**Roof Membrane Replacement
Eunice D. Powell Hall
Alcorn State University
Lorman Campus
Project Number: 2016-003**

Addendum No. 2

09June2017

3 ROOF DETAIL

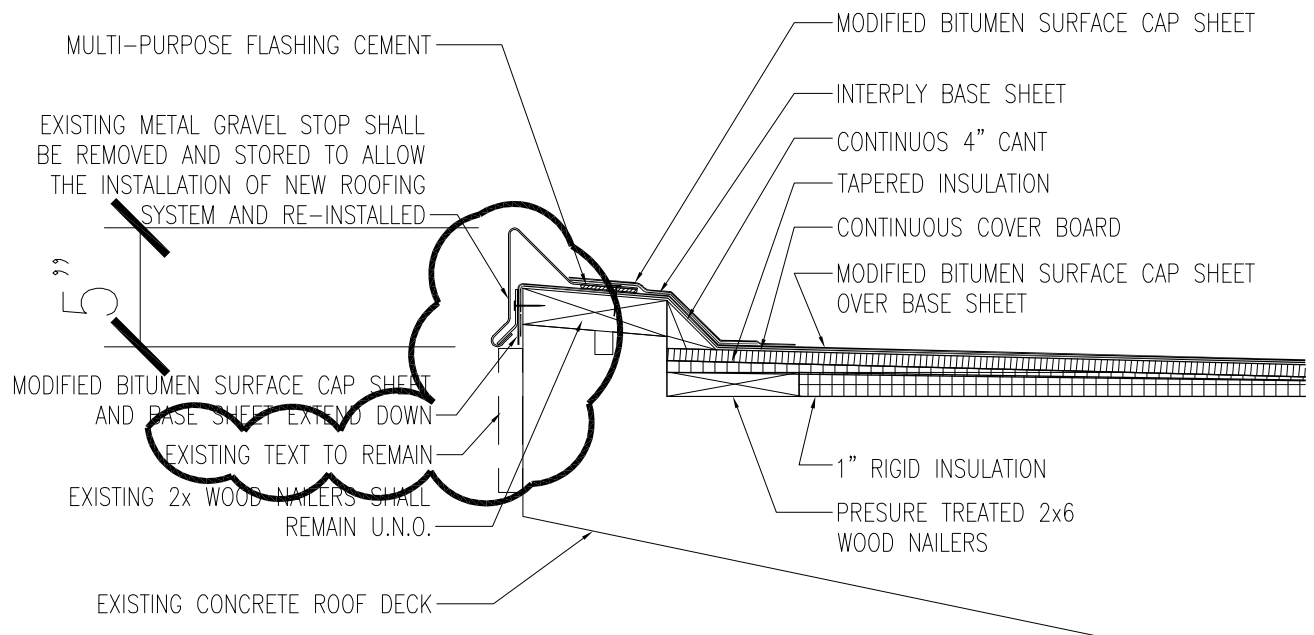
Detail 3 on Sheet A-3.

Detail 3 on Sheet a-3 is hereby revised. The existing text on the face of the entry canopy shall remain. Adjust the vertical height of the gravel stop fascia to accommodate the location of the text on the concrete fascia.
